AUDIT REPORT
OF
“NORTHERN EAST-WEST HIGHWAY PROJECT”
IMPLEMENTED BY
REGIONAL OFFICE, TRONGSA, DEPARTMENT OF ROADS,
MINISTRY OF WORKS AND HUMAN SETTLEMENT

PERIOD: INCEPTION TO 30 JUNE 2017

RAA/AR/ DSA-SCID/RO-L/thang/2019/15956

Subject: Audit Report of “Northern East west Highway Project”of Regional Office, Trongsa for the period from inception to 30.6.2017

Fig: 2.1 –Initial approved design and drawings

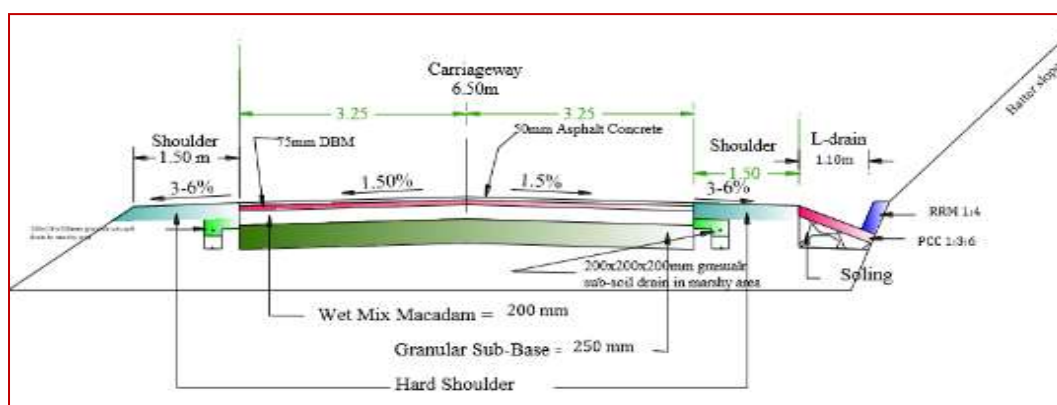
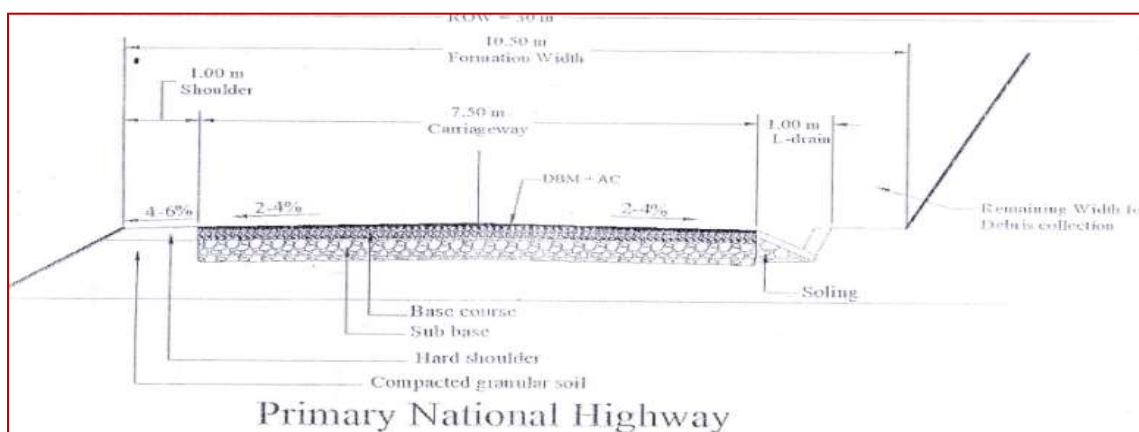
However, vide letter No. MoWHS/Sec-29/2015-2016/524 dated 16th October 2015, the Secretary, MoWHS had conveyed the meeting held on 16th June 2015 with the contractors and directed the Regional Offices for issuance of amendment to the contract agreements based on the decisions subsequently taken to increase the carriageway width from 6.5m to 7.5 m. Reasons for increase of carriageway width was found not documented.

In addition, vide letter No. DoR/ROL/16/15-16/481 dated 21/10/15, all Regional Offices were informed to increase the pavement width from 6.5 meters to 7.5 meters. In line with change order, the revised drawing developed and circulated by Design Division, DoR Thimphu was as depicted in the photograph below:

Thus, the increase of pavement width of 1m from the initial carriageway width of 6.5m to 7.5m after a time lapse of almost eight months from the dates of awards of contract works was irrational and inappropriate as it had not only distorted the drawings, estimates, BOQs, Projected Cost and funding modality but also adversely impacted the overall project cost by **Nu. 317,636,875.54** as summarized in table 2.1 below:

The Regional Offices in consultation with the Ministry should comment on the changes of drawings and technical specifications after the awards of contract works that had resulted in additional avoidable financial implication to the extent of **Nu. 317,636,875.54**.

It is thus evident that the change of designs and drawing and technical specification on the increase of Impavement width after award of contracts and during execution phase of contracts was an adhoc decision and was also not aligned to the approved design and

technical specification of the Guidelines. The change of designs by doing away the 1.5m shoulder width between L-Drain and carriageway and reduction of 1.50 m to 1m at valley sides had resulted in compromising necessary safety measures and safety of commuters.

In addition, the extra financial burden to the government due to change is design and technical specification particularly due to increase of 1m carriage way alone after the contract awards amounted to Nu. 317.637 million (**Ministerial Level Committee were responsible for the changes**)

The Ministry should not only strengthen the Design Divisions for accurate designing of road structures but also institute a technical team to review project plans, designs, and specifications to ensure that the same are accurate and complete including verification of the accuracy of surveys for future projects as to prevent changes in designs as well as time and cost overruns.

Figure 2.5(3): Revised drawing No. 2: Pavement drawing followed by RO Thimphu and Trongsa

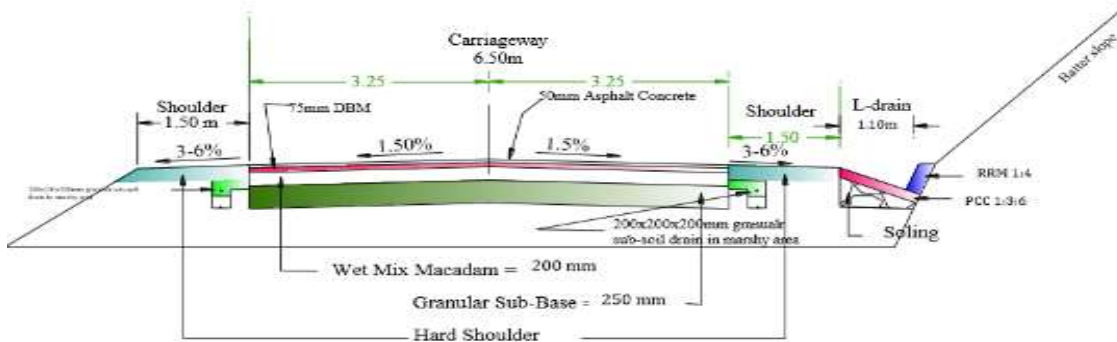
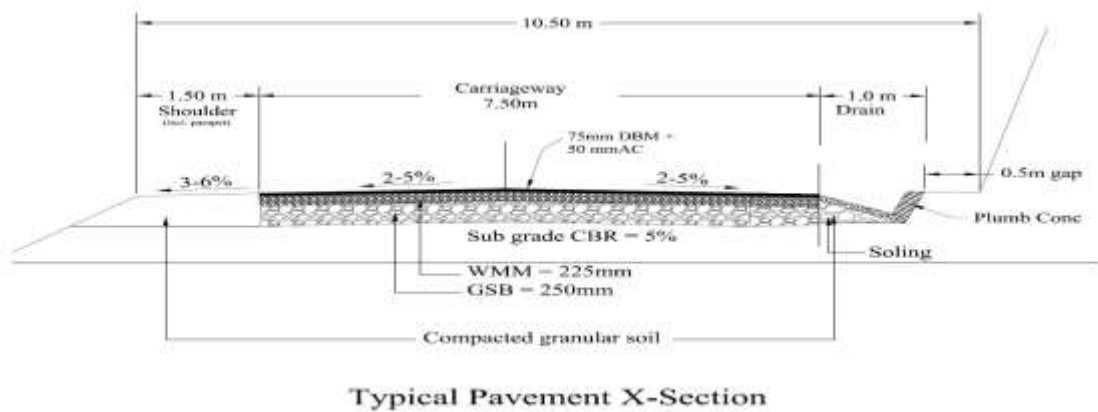
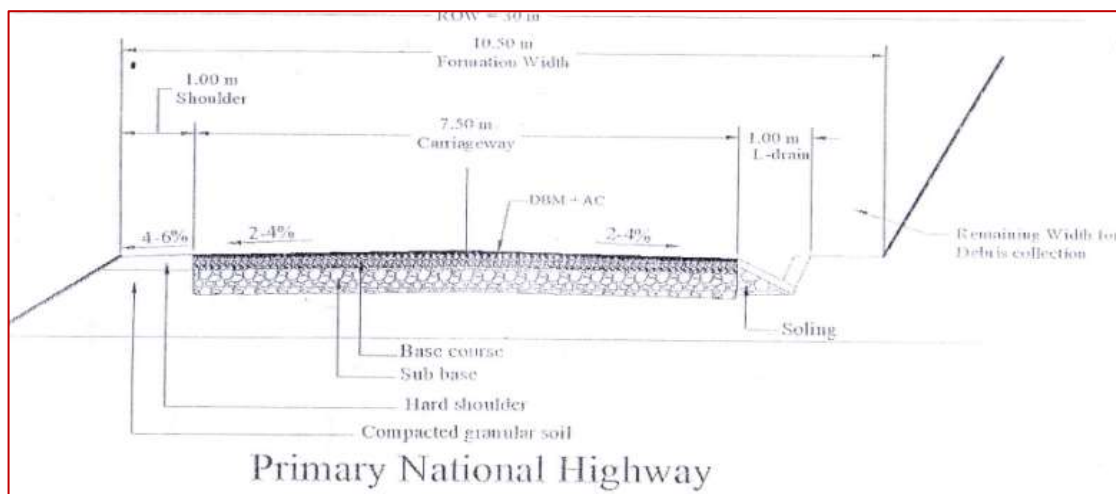
However, the Secretary, MoWHS vide letter No. MoWHS/Sec-29/2015-16/524 dated 16th October 2015 amongst others, directed all the Regional Offices on the decisions taken during the meeting held on February, 2016, after a time elapse of more than eight months from the commencement of the contract works, to increase pavement width from 6.5 m to 7.5 m and to issue amendment to the contract agreement signed with the contractors under respective jurisdictions.

In line with change order, the revised drawing was developed and circulated by Design Division, DoR Thimphu. However, during the course of the review of drawings implemented by the four Regional Offices, and site verifications, the audit team noted two (2) different drawings with difference technical specification for the same NEWH Up-gradation works.

It was noted that RO Thimphu and Trongsa were following one drawing and RO Lobeysa and Lingmethang were following a different as shown in Figure 1 & 2 below:

Thus, for the Primary National Highway, two different types of pavement drawings and specification were applied resulting in inconsistency in the implementation of Double Lanning works as well as non-adherence to the Road Design Standards specified in the *Guidelines on Road Classification System and Delineation of Construction and Maintenance Responsibilities 2009*.

Adoption of two different drawings with varying pavement specifications and non-adherence to the approved Road Design Standard indicated improper planning and lack of due diligence in the preparation of drawings and specifications. Such mismatches in technical specification of road works would inevitably result in execution of two different type of pavement works for the same NEWH double lanning works.

The ministry should review the circumstances leading to the implementation of two different sets of designs by the ROs besides instituting design review process to ensure consistent and uniform implementation of designs and drawing for similar projects in future.

In addition, the Ministry should also revisit the revised designs circulated to ROs, as the requisite gap between hillside and drains was found not maintained in majority of the work due to site specific and alignment problem of the drain works. Further, the Ministry should also relook on doing away of 1.5m Hard shoulders between the L-Drain and Carriageway in terms of risks towards safety of the commuters.

Fig: 2.6(2)- Revised design and drawing

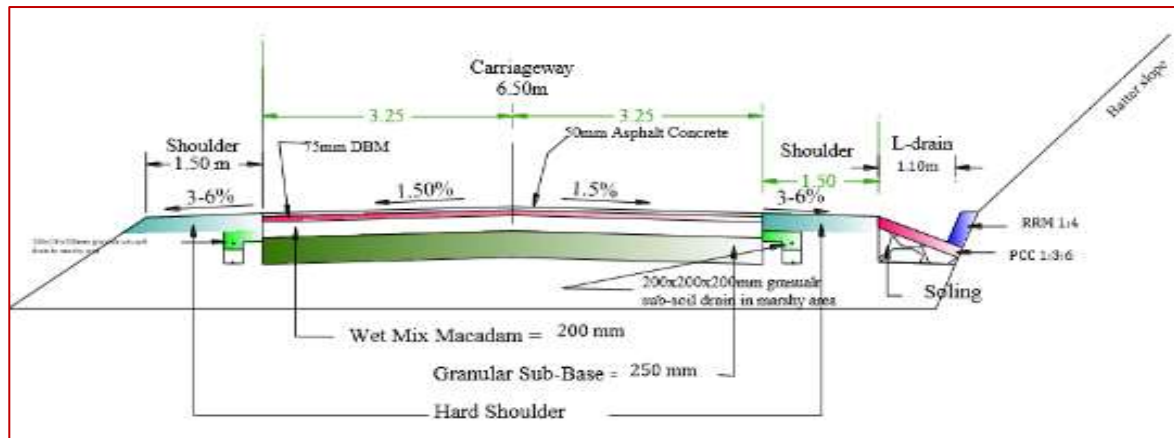
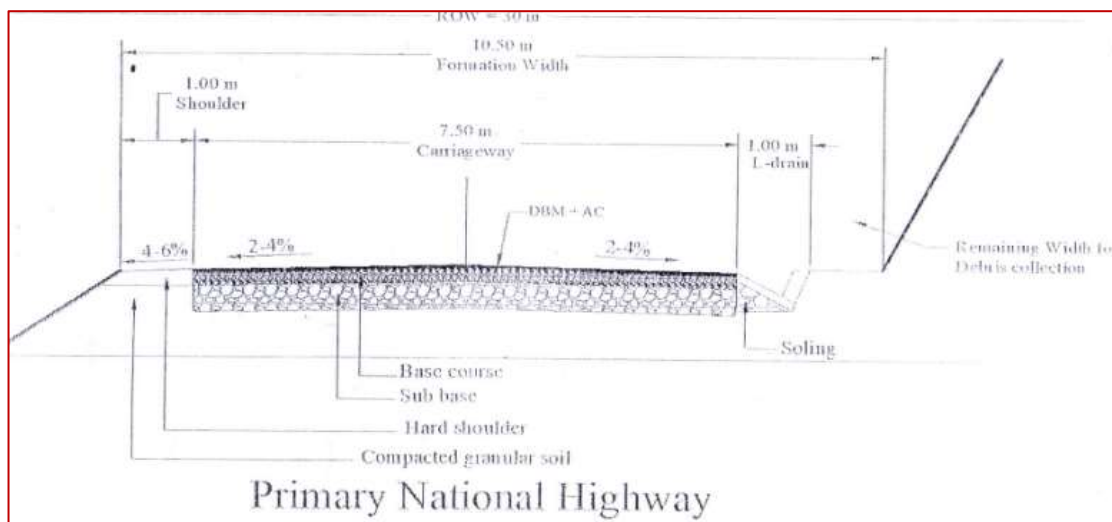
However, it was apparent from the records that based on the decisions taken during the meeting held in **February, 2016, after a time elapse of more than eight month from the commencement of the contract works**, drawings were found revised for different category of Road in Bhutan as depicted in the photograph below:

While the subsequent design and drawing had maintained increased carriage pavement width of 7.5m, other structural drawings were also changed from the initial designs and drawings as evident from the above photograph.

The above changes in the design and drawing not only resulted in extra financial implication to the government exchequer for increase of 1m carriage width to the extent of approximately Nu.317.637 million but also impeded timely completion of work due to grant of time extension for the increased scope of work as well as compromised safety measures by doing away Hard shoulders of 1.5m width between the L-Drain and Paved carriageway width including reduction of 0.5m hard shoulder at valley side. Besides, due to design changes, overall formation width of 10.5m were found not achieved as 1m width supposedly maintained for Debris collections between hillside and L-Drain were found not maintained in entirety for all stretches of the roads as majority of the L-Drain was found constructed attached to the hillside. Further, 1m shoulder width on the valley sides were also found not maintained as in some stretches of roads the pavement road were found executed at the edge of the road width.

As discussed in the exit meeting, the DOR in consultation with the Ministry should revisit the revised drawing for appropriate decisions and taking measures to address any technical flaws and ambiguities. Besides, the Ministry should also look in to the requirement of approval of Cabinet on the revised designs as it had deviated from “The Guidelines on Road Classification System and Delineation of Construction and Maintenance Responsibilities 2009”.

Fig: 2.22- Initial approved design and drawing

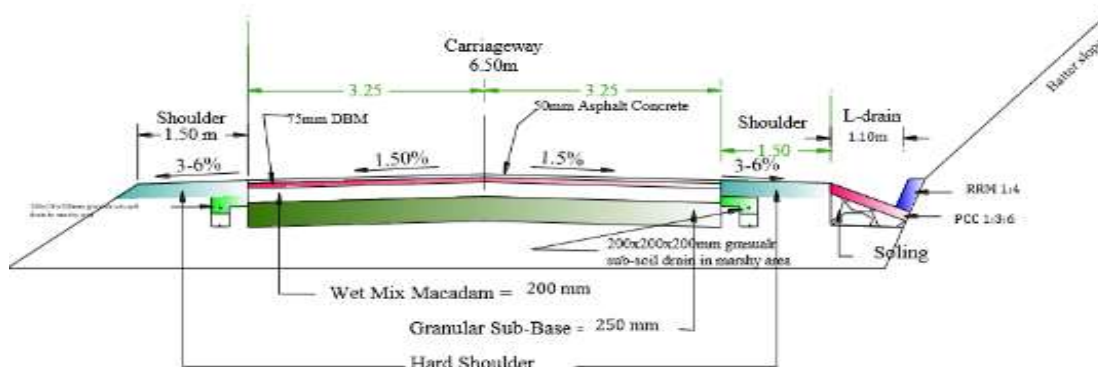
Northern East-West Highway being the Primary National Highway, both the initial and revised drawings has specified a total pavement thickness of 600mm as shown in the diagram and in the table below:

Fig: 7.2- Approved drawing for culvert

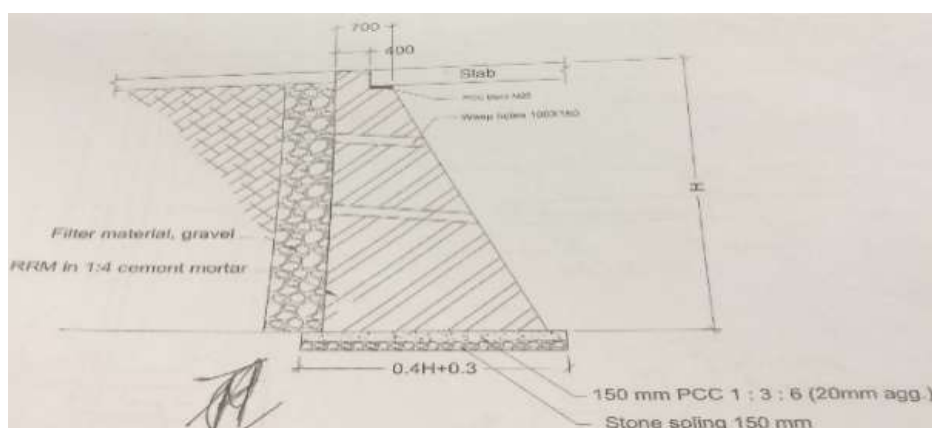
The drawing for RCC culvert does not show PCC 1:3:6 coping of 100 mm thick on 400mm thick top wall as shown below:

However, the contractor was paid Nu. 4,950.00 (1.65cum @ Nu. 3000) (*Refer MB 13page no 18*) for providing 100mm thick coping on top wall. During the physical verification of the structures, the coping work was found not provided as evident from the photographs depicted below:

Fig: 9.2- Approved drawing for parapet

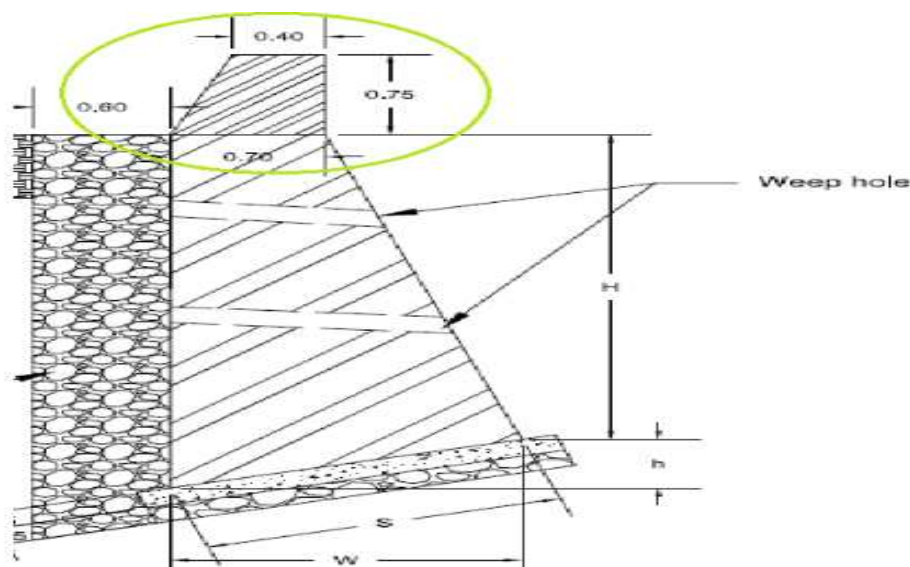
The parapet dimension was specified as 0.4m x 0.75m x 0.70m as per the standard drawing and design given below:

However, during the site verification of the structures, it was observed that the parapets constructed along Chainages 48.08km, 48.54km and 47.92km were irregular in shapes and with varying dimensions as evident from the photograph depicted below:

Fig:12.1- Significant cracks developed

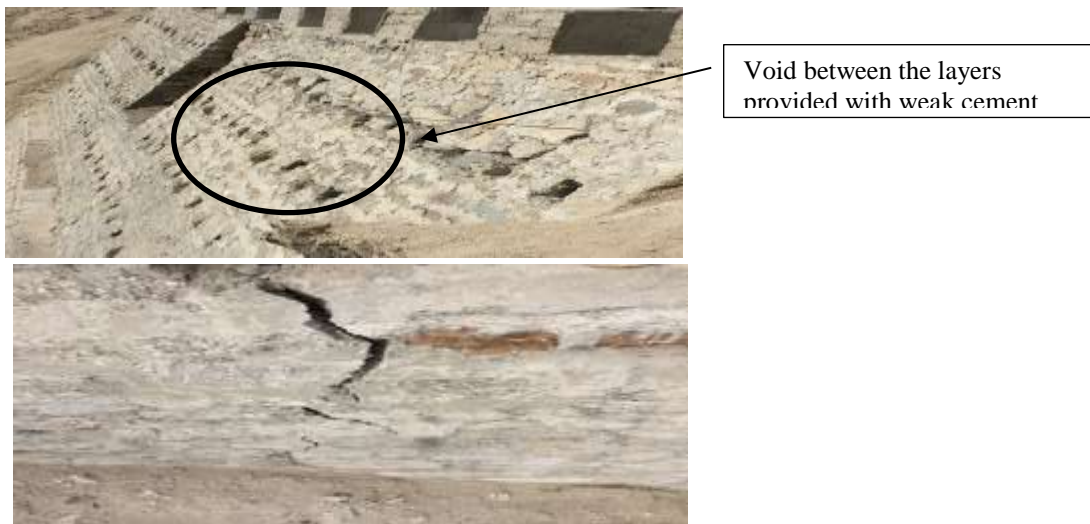
The pictorial evidences of damaged RRM walls are depicted in the photographs below:

Para: 21.2(2)- Sketch drawing is as shown below

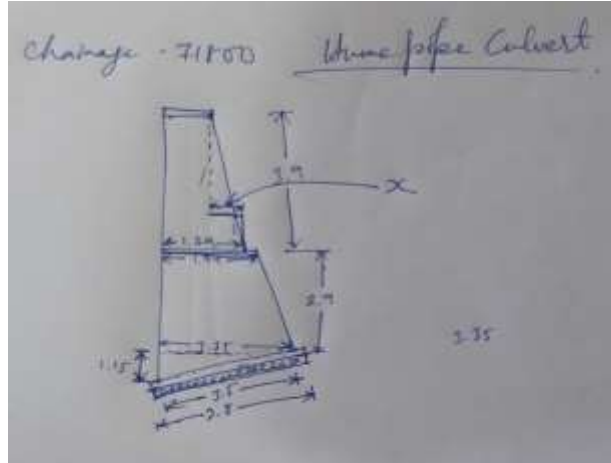
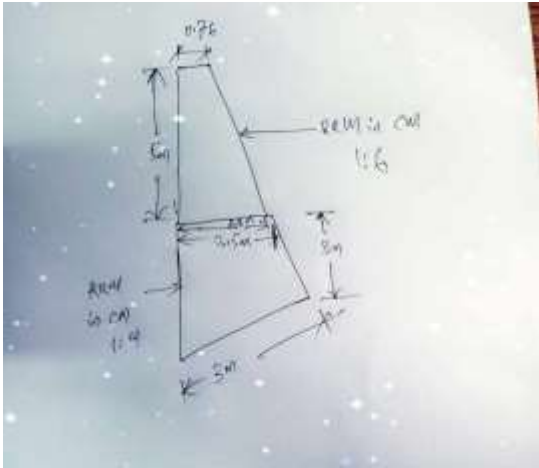
As seen in the photograph below, the vegetation at the base of the wall is indication of marshy area.
